October 27, 2021

RE: **Lot 12 Block 8 Volcano Cliffs Unit 22 SAD 228**
6312 Canavio Rd. NW
Grading and Drainage Plan
Engineers Stamp Date 8/30/2021 (D10D003E12)
Pad Certification Date 10/8/2021

DRAINAGE AND TRANSPORTATION INFORMATION SHEET (REV 6/2018)

ENGINEER'S SEAL	LOT 12 BLK 8 UN 22 VC 6312 CANAVIO RD NW	DRAWN BY DEM
 8/30/21		DATE 8-27-21
		Lot 12 Blk 8 Un 22 VC. DWG
DAVID SOULE P.E. #14522	 P.O. BOX 93624 ALBUQUERQUE, NM 87199 (505) 321-9099	SHEET # C1
		JOB # _____

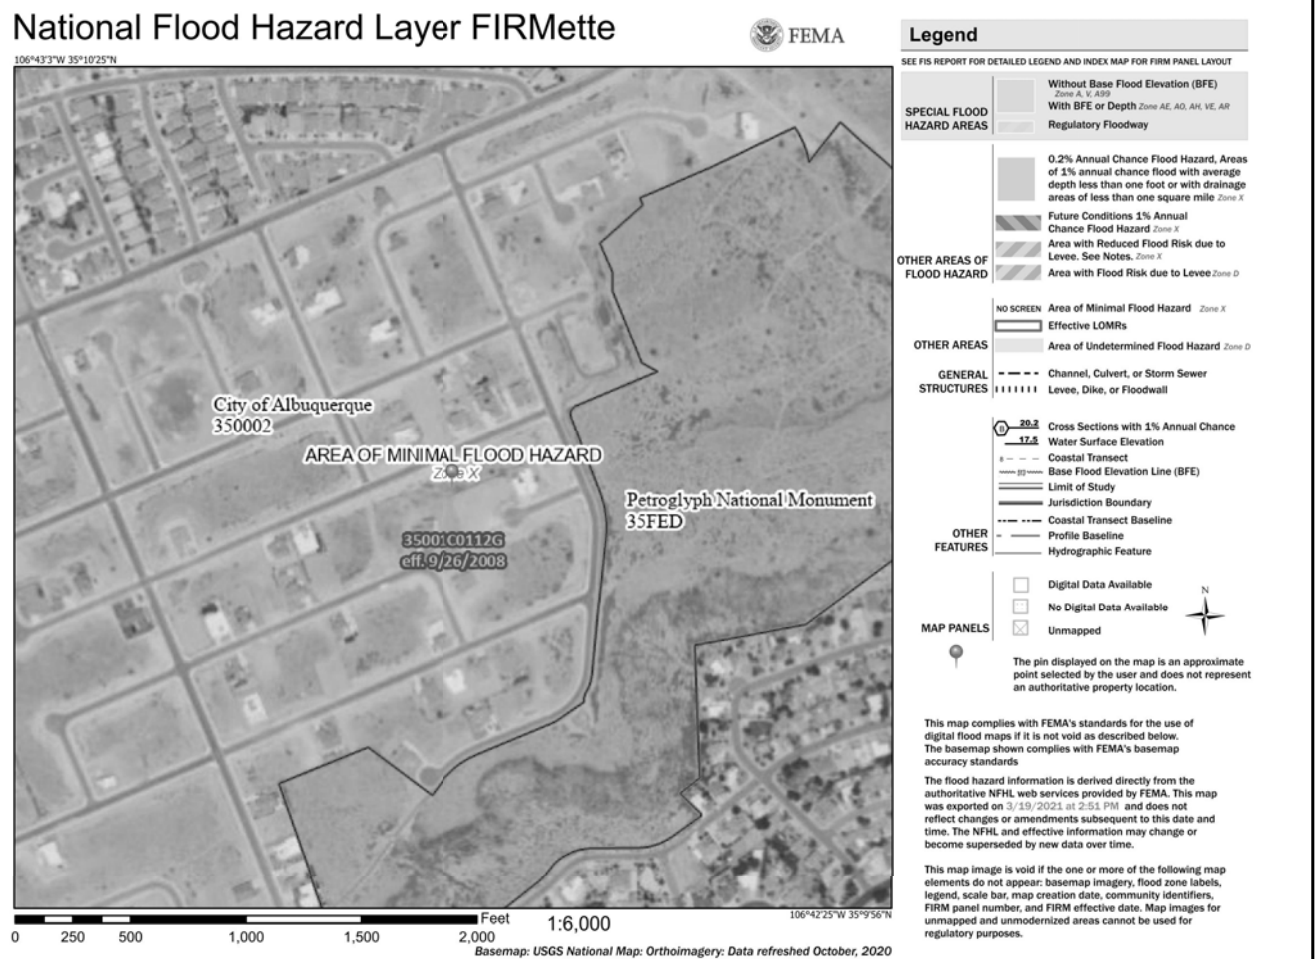
Based upon the information provided in your submittal received 10/27/2021, this plan is approved for Building Permit.

Reiterate to the Owner/Contractor that a separate permit for a garden/retaining wall must be obtained, with the approved G&D plan and Pad Certification. Also, let the owner/contractor know that if a pool is to be added in the future the G&D plan will need to be modified showing the location of the pool and the land treatment differences. Also advise the owner & Contractor that dirt is not allowed in the public right of way to climb the curb. Crusher fines or lumber is allowed. If dirt is used this will delay going forward with the construction of the home.

Prior to Certificate of Occupancy release, Engineer Certification per the DPM checklist of this plan will be required.
